Mods to the ETI-152 Capacitance Meter

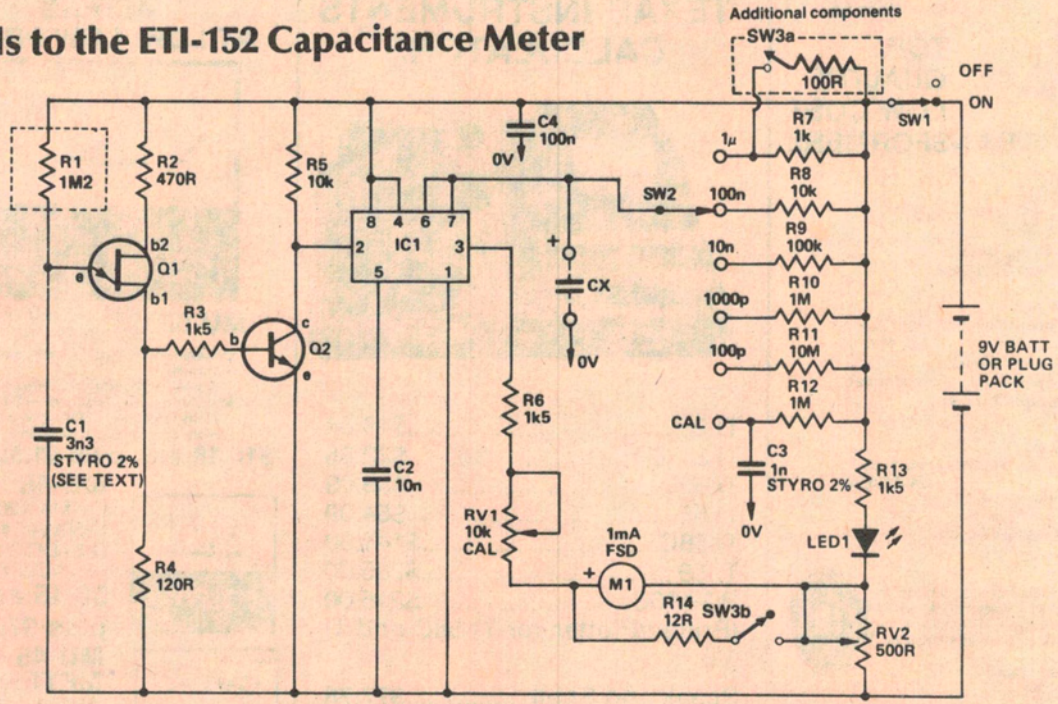
This project appeared in the February 1980 issue and was part of a short series of look-alike test instruments. Several readers pointed out that the unit did not work properly in the 1µ/x10 mode (i.e: 10µ full scale) as the integration time was not long enough. This problem is cured by a simple modification.

Apart from that, some constructors found that RV2 (zero set control) was very close to one end of its range and difficult to adjust. This is probably brought about by LED1 having a fairly high voltage drop. To cure the problem, reduce R13 to 820 or 680 ohms.

Firstly, SW3 should be changed to a double-pole, single-throw (DPST) type. Secondly, change R1 to 1M2, as shown in the new circuit diagram here. Add a 100 ohm resistor, switched across R7 by the other pole of SW3, as shown in the circuit diagram.
